BOROUGH OF OCEANPORT PLANNING BOARD

REGULAR MEETING • AGENDA

SEPTEMBER 8, 2026 at 7:00 PM

- 10.2. PB2026-08 Old Wharf Development, LLC
Block 121, Lot 1.01 & 2
298 & 306 East Main Street

1/16"=1'-0"

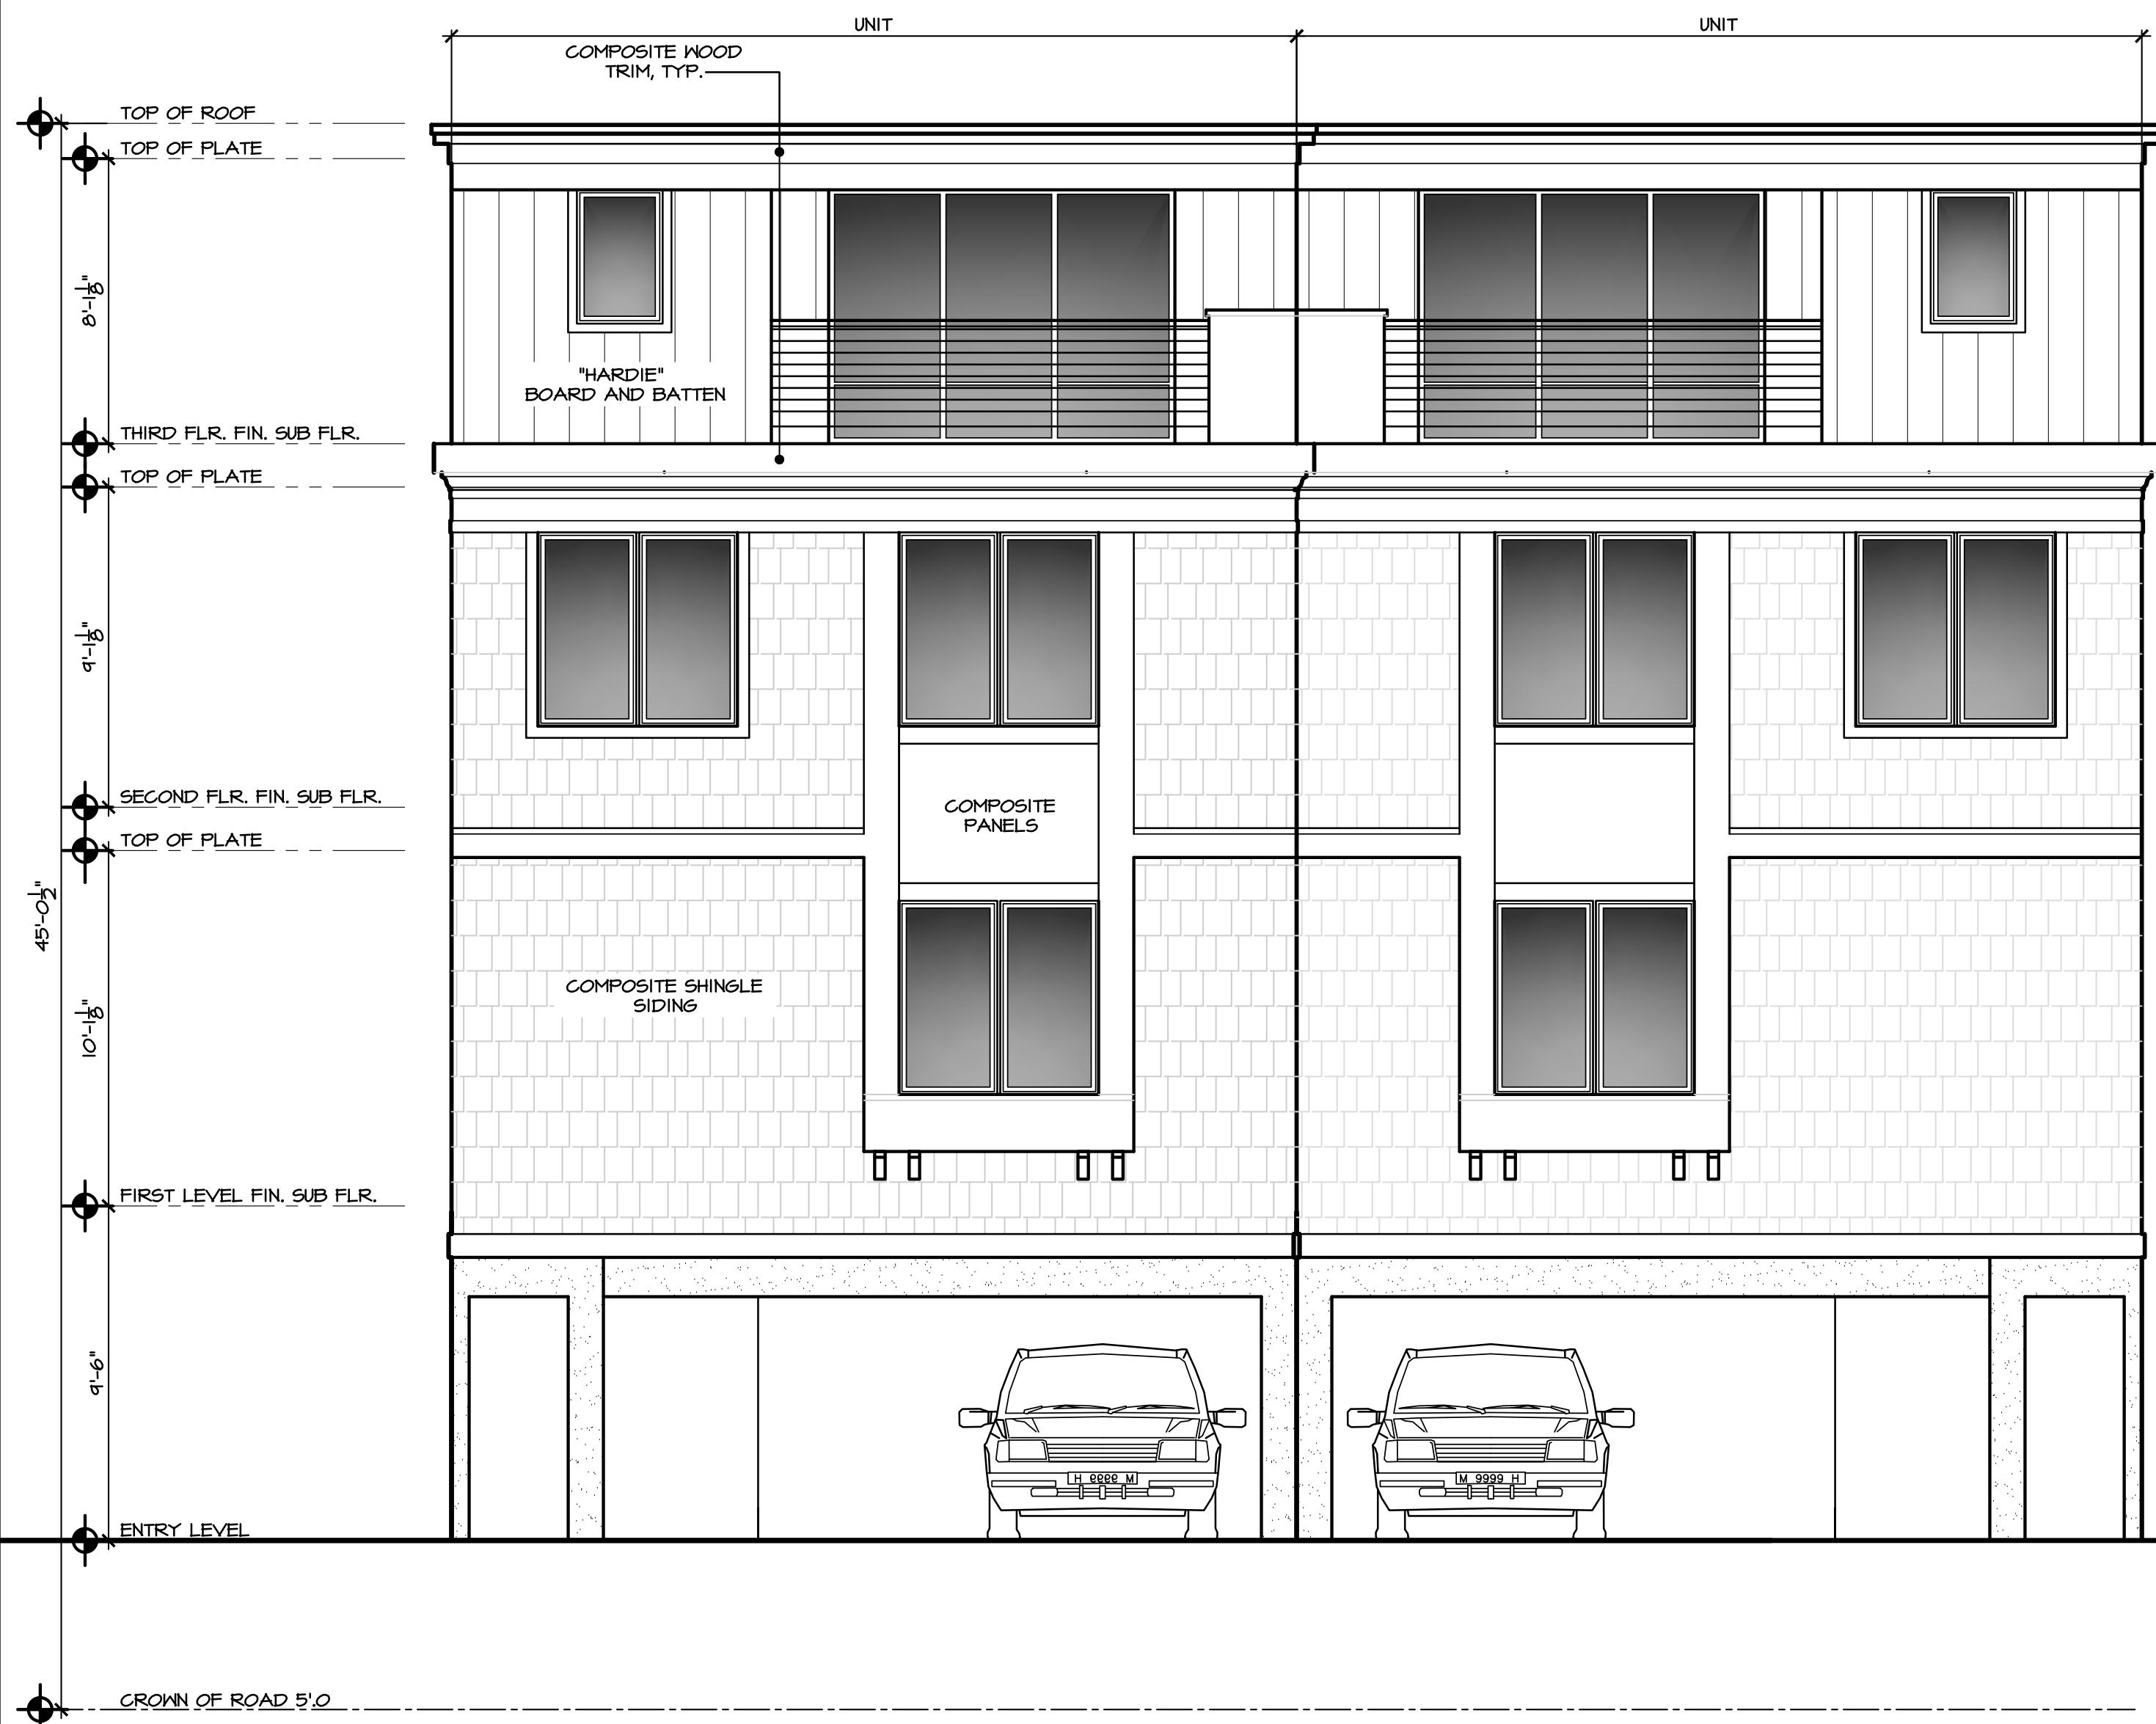
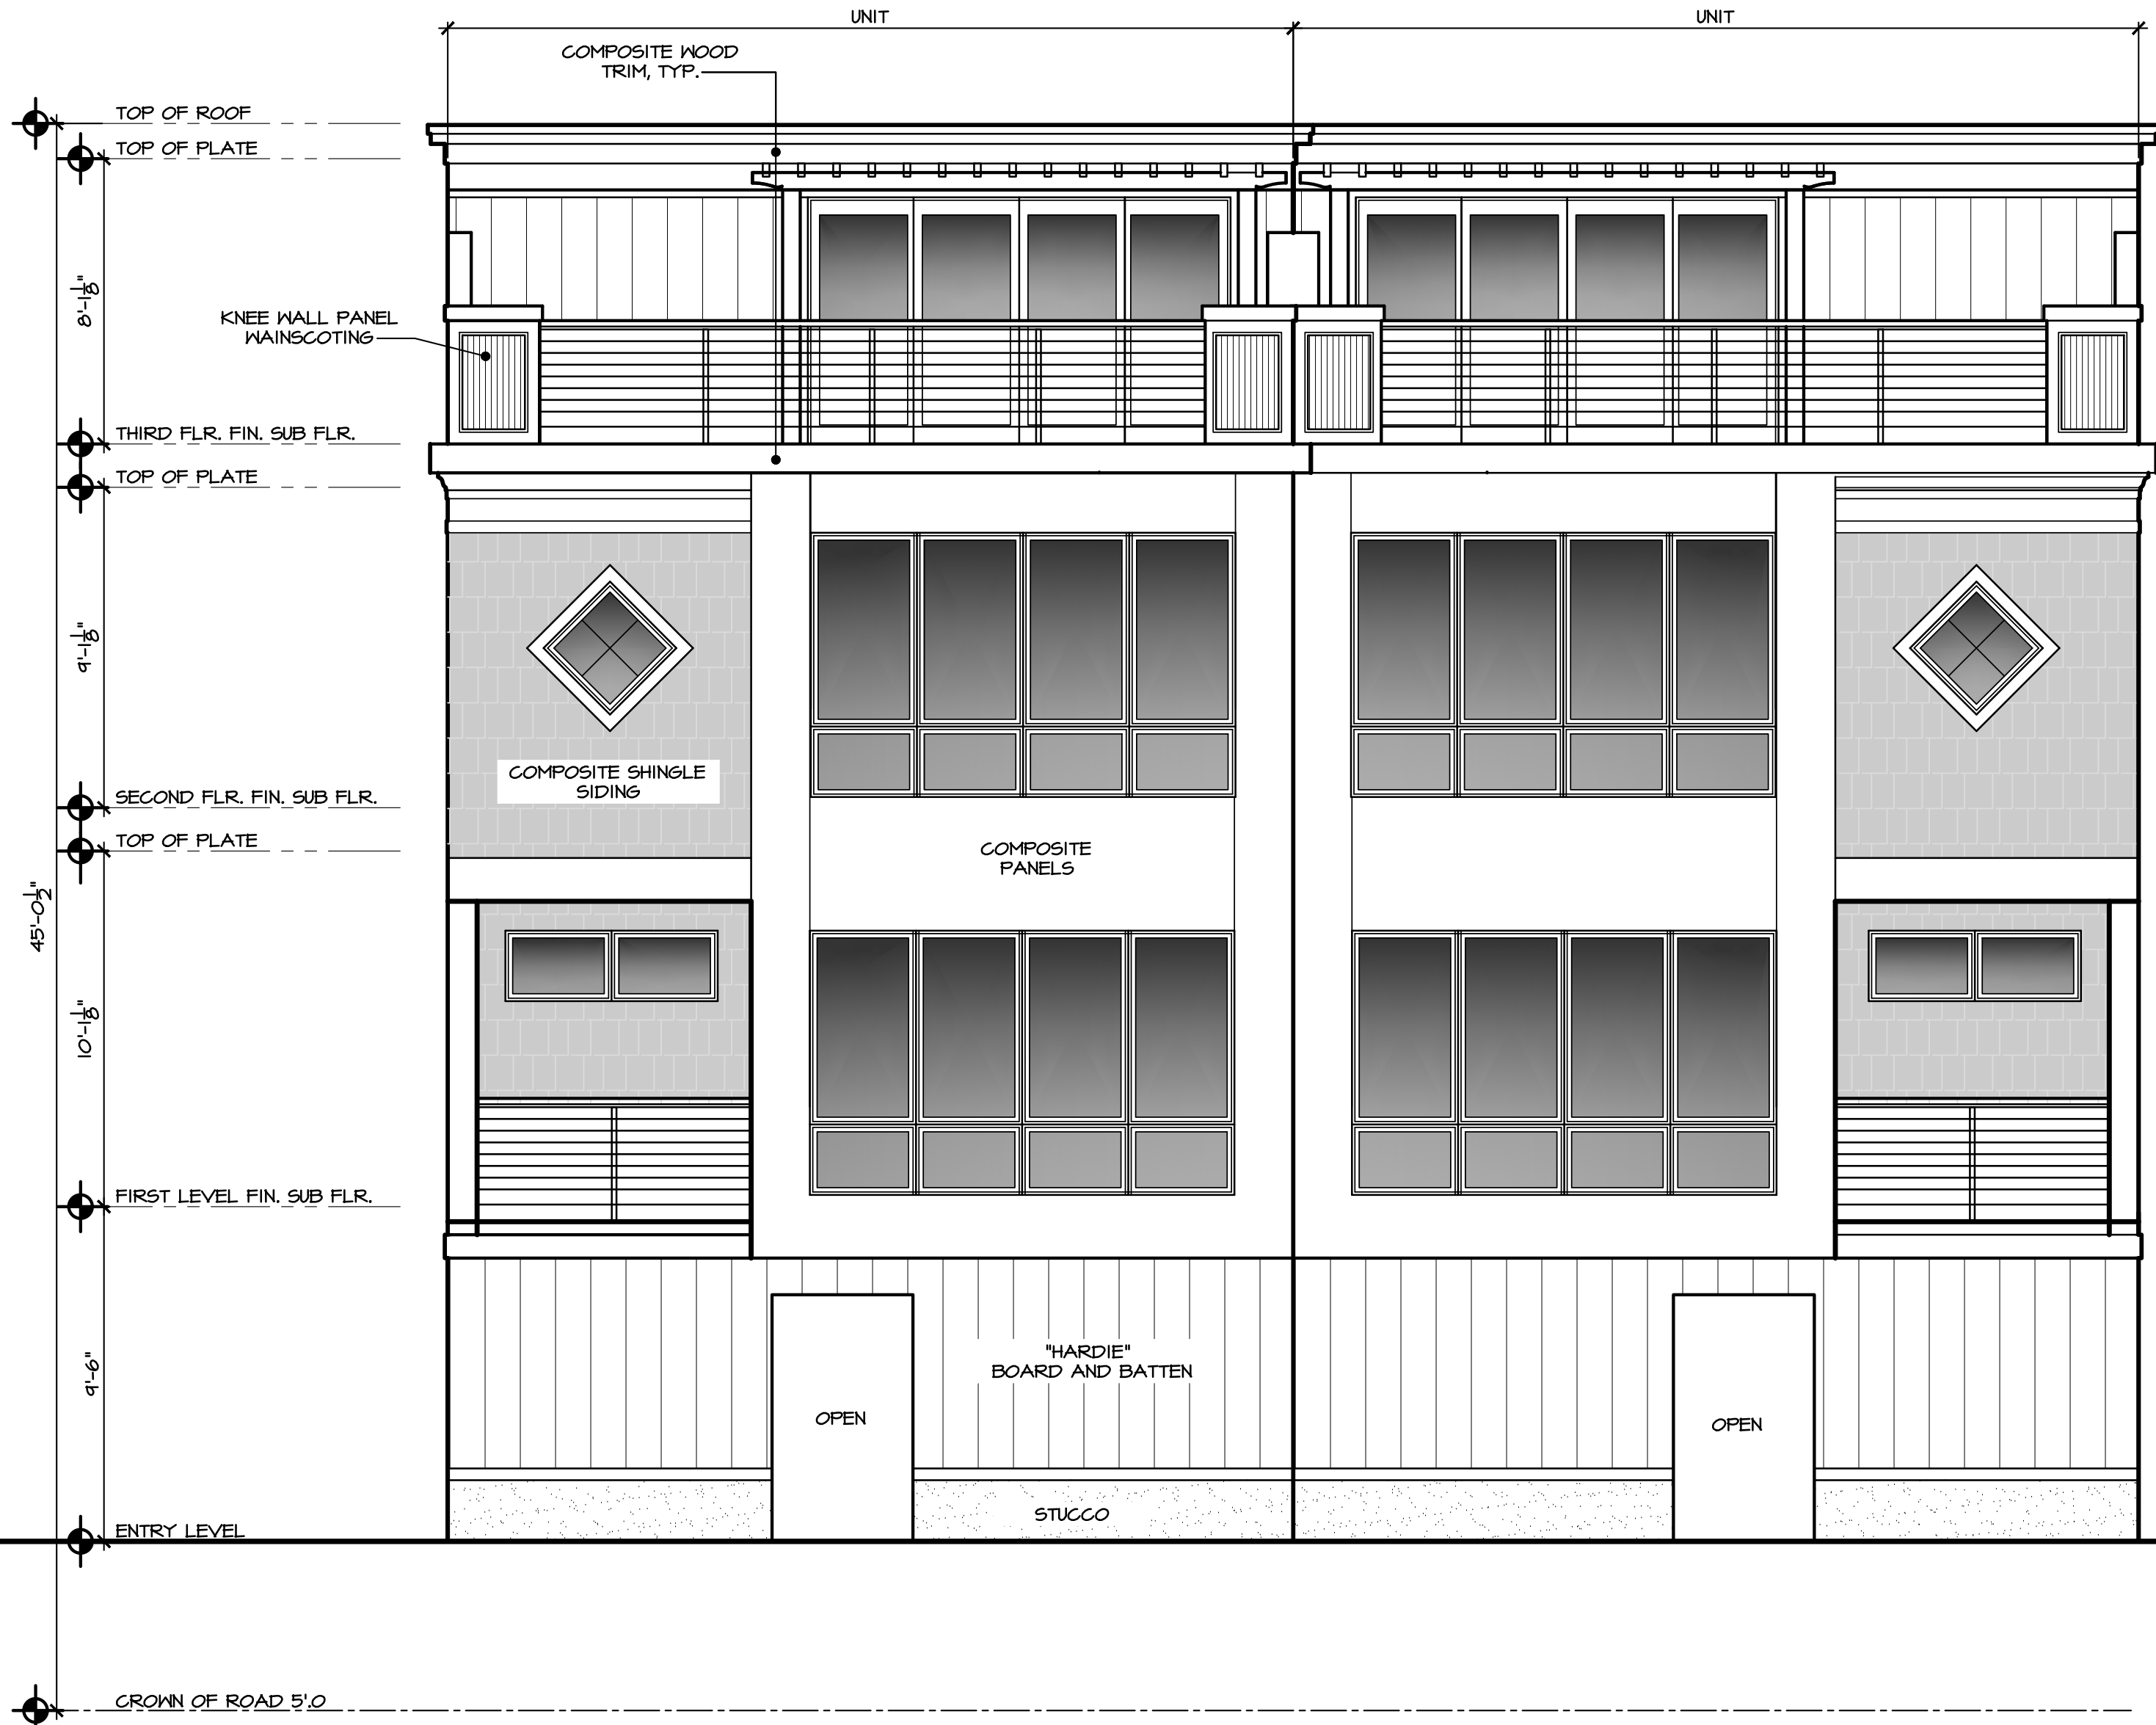
2. Testimony shall be provided as to the height of each building as the Architectural plans indicate that Building B exceeds the permitted height of 45 feet.
3. The parcels are situated within the AE8 Flood Zone. Clarification is required regarding the layout and elevation of the entry level for Building B, as well as the potential need for flood venting.
4. The applicant is requested to confirm whether NJAWC will require a "Hot Box" for the incoming water service. If required, please specify its proposed location.
5. The improvements will disturb portions of the paver sidewalk along East Main Street. These areas and any settled area of the sidewalk shall be reconstructed with matching materials.
6. Structural Designs and computations shall be provided for all retaining walls that are signed and sealed by a New Jersey Professional Engineer.

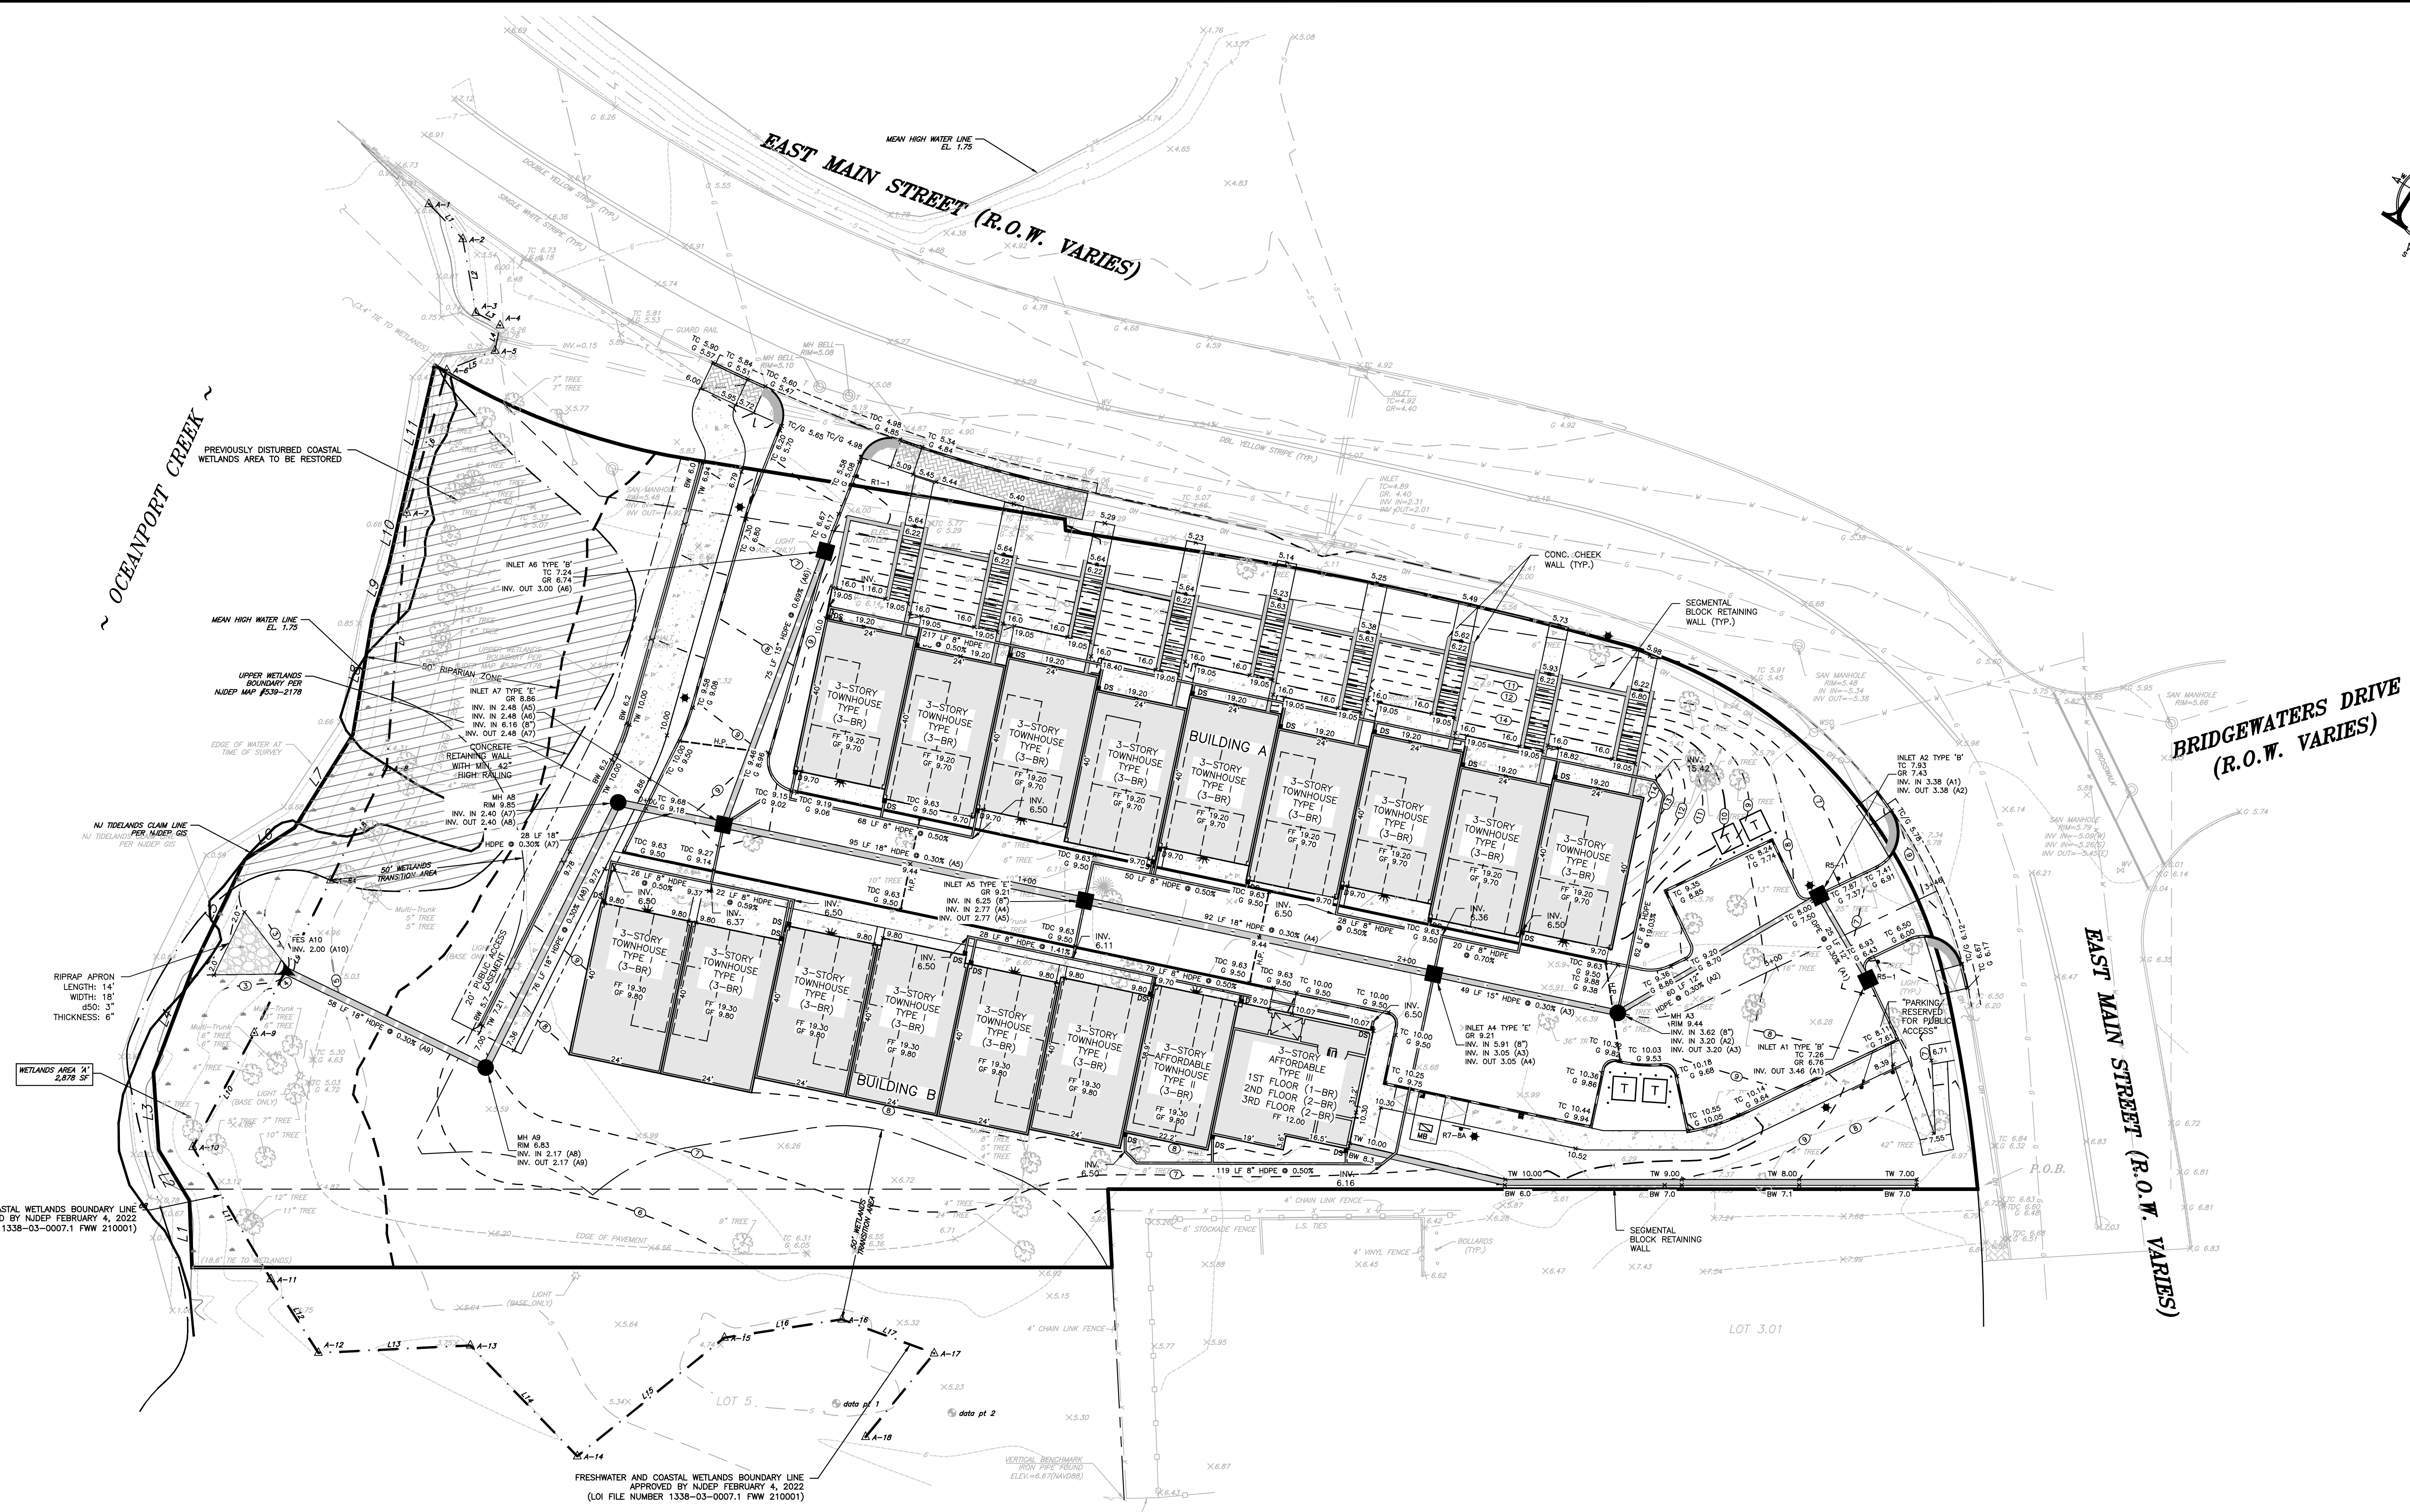
13. Detailed grading is needed on the north side of Building A around the stairs and terraced landscaping. Top and bottom of wall shots shall be provided. The applicant shall verify if the change in elevation from the front porch down to the landscaping meets or exceeds 30" which would trigger the requirement of a guard.

15. Contour 6, located at the rear and side yard adjacent to the playground on Lot 3.01, extends across the subject property. The current proposed grading plan does not appear to address this condition.
